SUBJECT: ISSUANCE OF AMENDMENT - JOSEPH M. FARLEY NUCLEAR PLANT, UNIT 1
(TAC NO. M91048)

AMENDMENT TO FACILITY OPERATING LICENSE

Amendment No. 117
License No. NPF-2

SAFETY EVALUATION BY THE OFFICE OF NUCLEAR REACTOR REGULATION

FIGURE 3.4-1

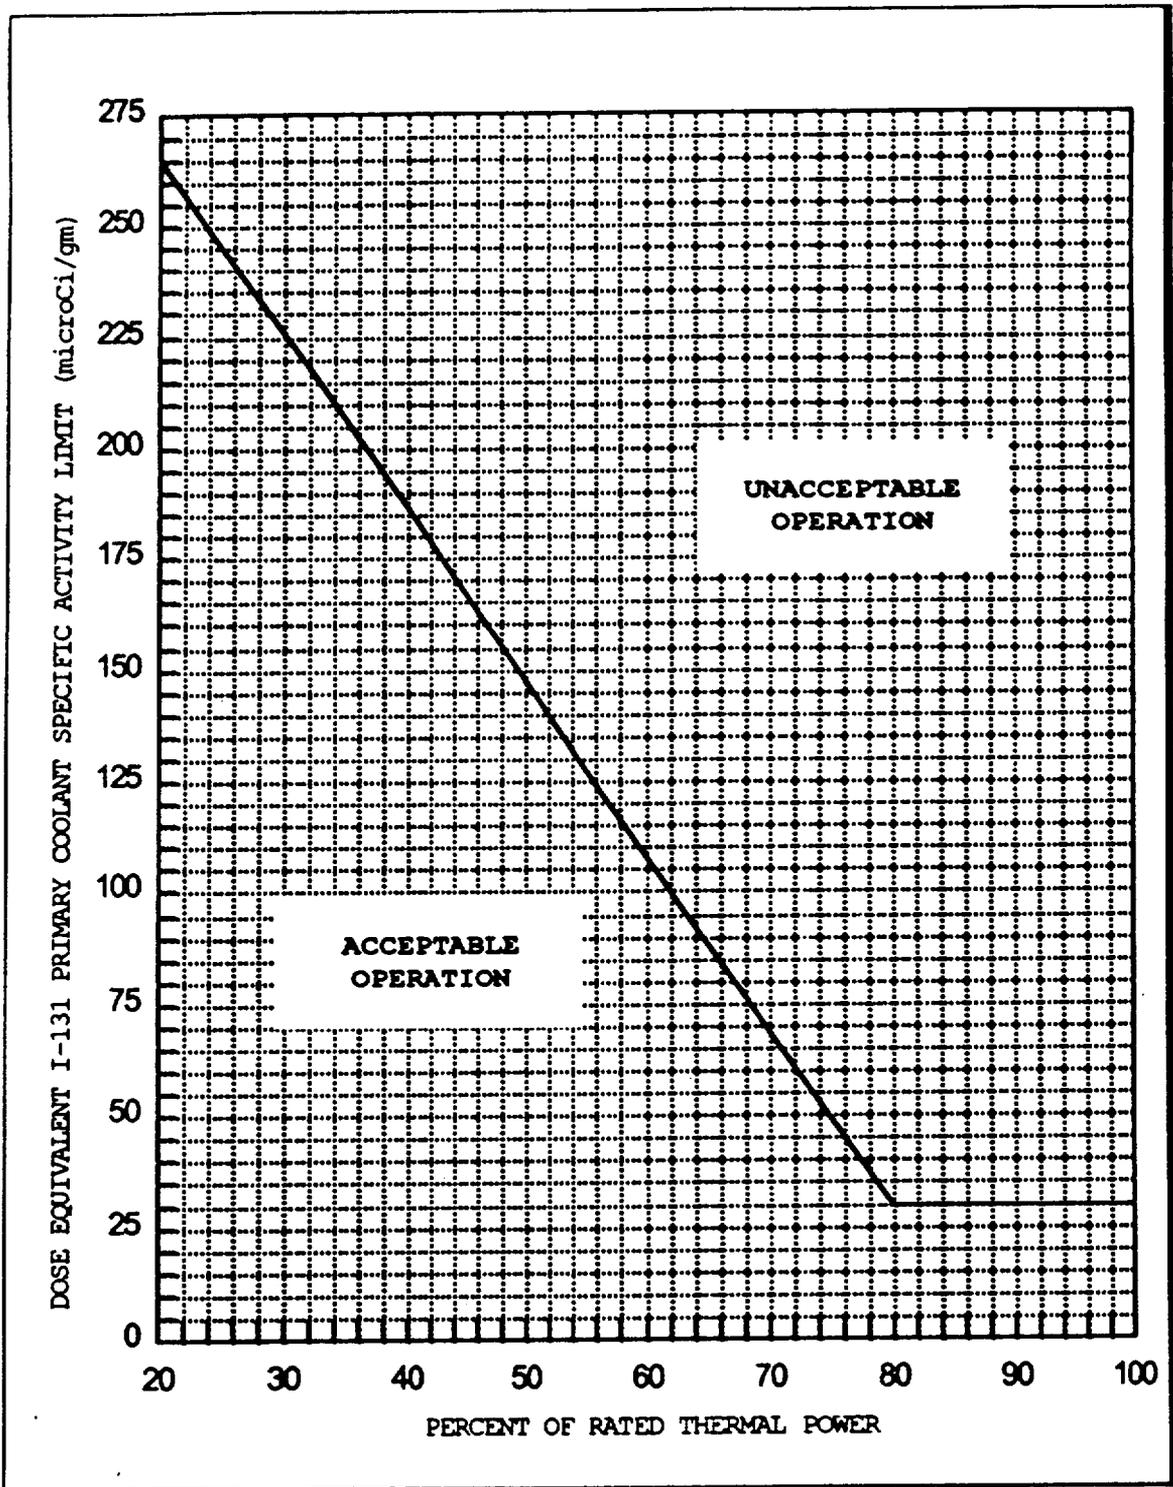
- a. With the specific activity of the primary coolant greater than 0.5 microCurie per gram DOSE EQUIVALENT I-131 for more than 48 hours during one continuous time interval or exceeding the limit line shown on Figure 3.4-1, be in at least HOT STANDBY with T_{avg} less than 500°F within 6 hours.
- b. With the specific activity of the primary coolant greater than $100/\bar{E}$ microCurie per gram, be in at least HOT STANDBY with T_{avg} less than 500°F within 6 hours.
